DOE RESPONSES TO WVDP PHASE 1 DECOMMISSIONING PLAN RAIS

RAI: DOE did not provide sufficient support that the selection of parameter values in the deterministic analysis is sufficiently conservative to demonstrate compliance with LTR criteria. (Section 5.2.4)

UPDATED DOE RESPONSES TO WVDP PHASE 1 DECOMMISSIONING PLAN RAIS

Figure Att-2. Cumulative Probability Dose-Source Ratio, Sr-90 – Surface Soil

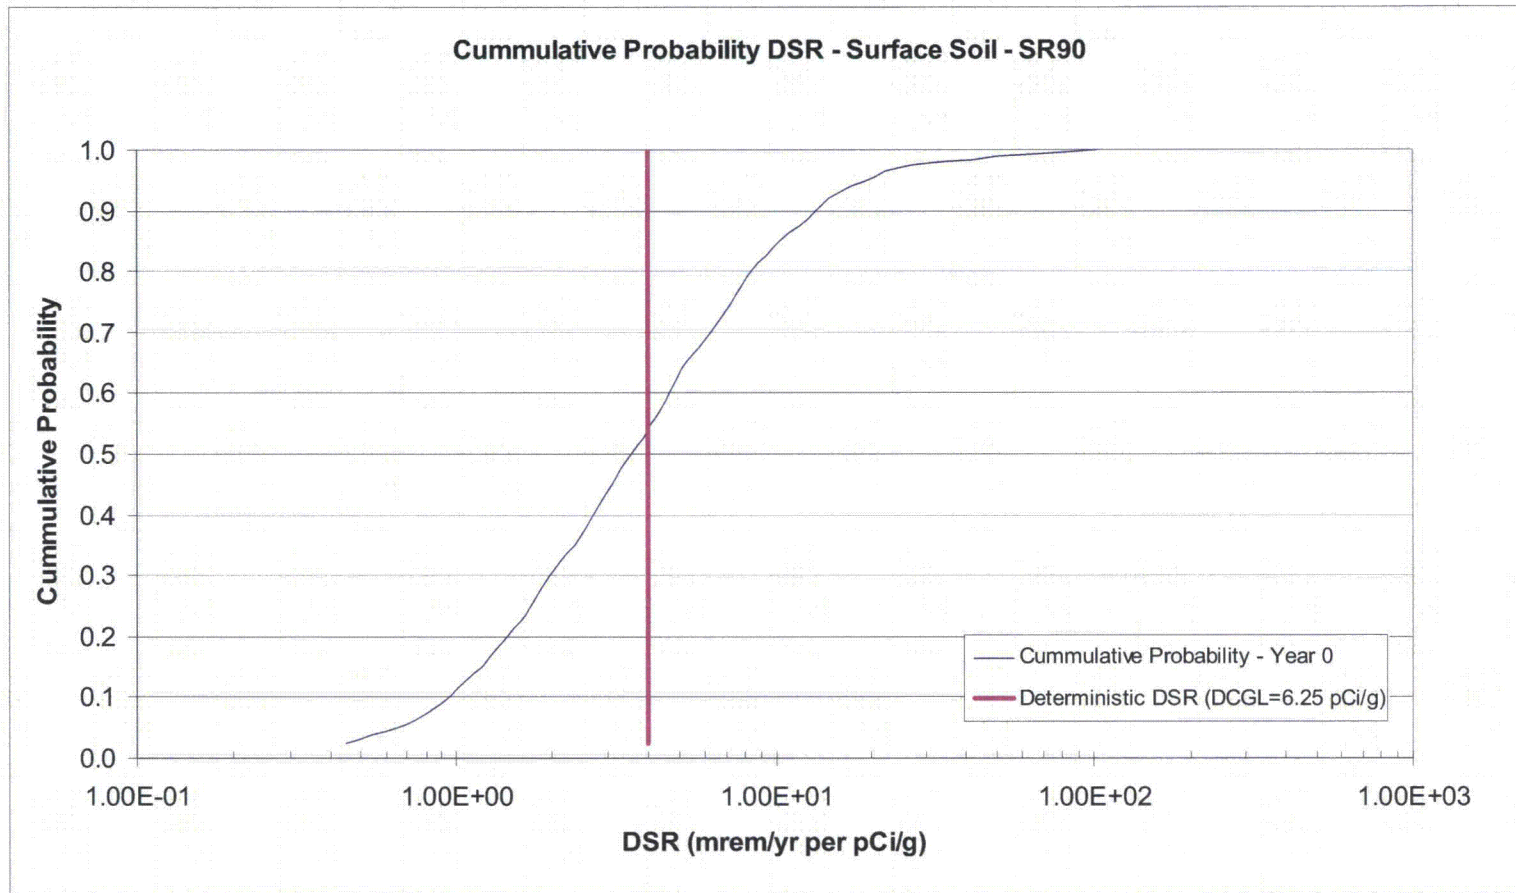
The lack of conservatism in these surface soil criteria can be quantified in another manner by considering the average soil concentrations at the deterministic DCGLs. If the average residual concentration of Sr-90, for example, were to be 6.25 pCi/g (the deterministic DCGL for surface soil), then the probabilistic modeling would indicate that the probability that the resulting dose would not exceed 25 mrem in the peak year would be approximately 55 percent (see Figure Att-2 in Attachment 1).
